SUMMARIZATION OF NEW APPENDICES (B, C, D, E, F, G, H)

DATE: June 15, 2026

TO: The City of Lebanon Wastewater Treatment Plant Site Selection Committee & Lebanon City Council

RE: Supplemental Public Comments and Risk Assessment regarding the Proposed 20 MGD Wastewater Treatment Facility

Exhibit C-1: 0.5-mile, 1.0-mile, and 2.0-mile rings centered on 3230 Mann Road, plotted on the TDEC Water Wells Desktop Application map. Each dark dot represents a permitted private water well in the TDEC database.

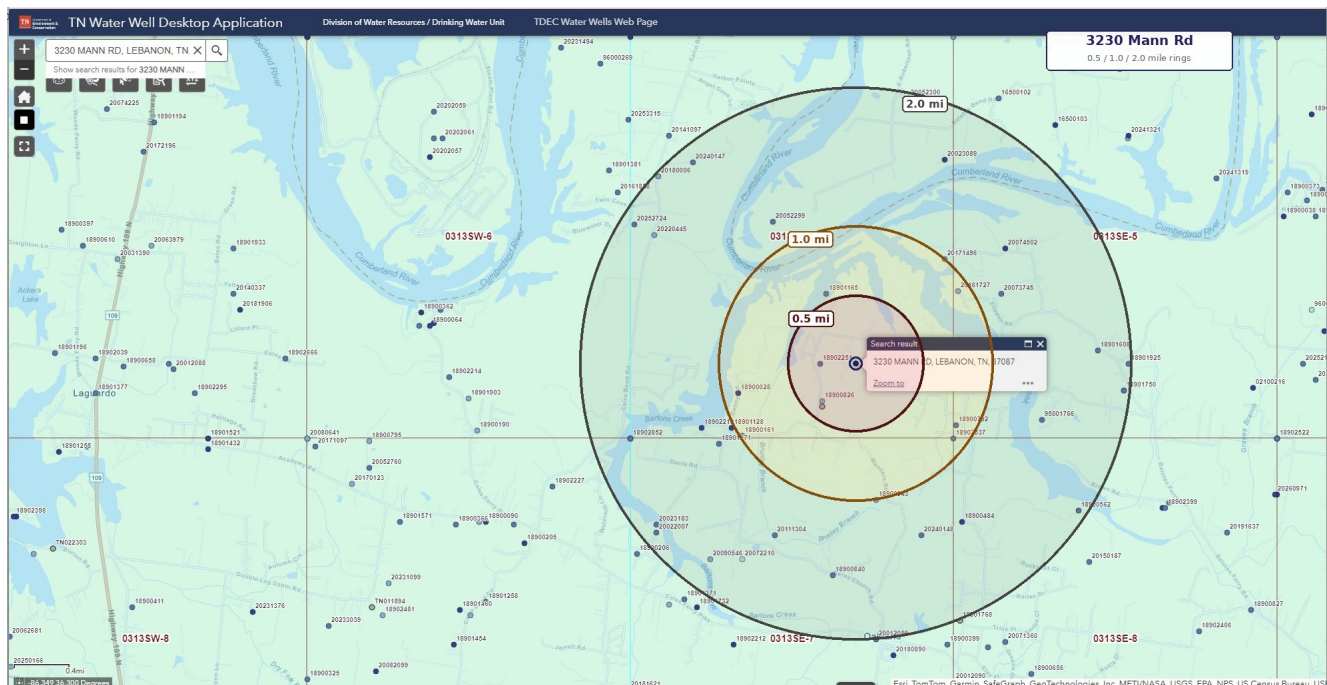
A query of the Tennessee Department of Environment and Conservation (TDEC) Water Well Locations public database identifies **a minimum of 38 permitted private wells within the 2-mile contamination radius** surrounding the proposed Mann Road and Berea Church Road footprint. Of these:

- **6 wells are located within 0.5 miles** of a proposed site, including a well at 1079 Berea Church Road (Coster) situated approximately 850 feet (0.16 mi) from the Mann Road site;
- **16 wells are located within 1.0 mile** of a proposed site;
- **38 wells are located within 2.0 miles** of a proposed site, the outer boundary of the karst contamination radius identified in Section VI.

The geographic distribution of these wells, with concentric 0.5-mile, 1.0-mile, and 2.0-mile rings, is depicted in Exhibit C-1 below. Recorded uses include residential drinking water (32 wells), agricultural and irrigation (9 wells), and geothermal heat pump (3 wells). The Site Selection Committee has not, to the petitioners' knowledge, entered these figures into the public record.

Important caveat: The figure of 38 wells is a minimum. The TDEC Water Well Locations database includes only those wells for which a licensed driller filed a report. Wells drilled prior to the establishment of mandatory driller reporting, owner-drilled wells, and wells for which a driller's report

was never filed are not represented. The actual number of households dependent on private well water within the contamination radius is reasonably expected to be materially higher.

- Formally request a hydrogeological study from a qualified third party documenting (or refuting) hydraulic connectivity between the proposed site footprint and the LUD well field;
- Require coordination with the LaGuardo Utility District Board of Commissioners as a prerequisite to any further consideration of the Mann Road and Berea Church Road addresses;
- Enter the well-count data and accompanying ring map (Exhibit C-1) into the official public record of the site selection proceedings, and supplement it with an independent staff verification against the most current TDEC Water Well Locations database;
- Provide written notification to each identified well owner, and to all LUD ratepayers, of the proposed siting and the karst-aquifer contamination pathway described in Section VI of the principal statement.
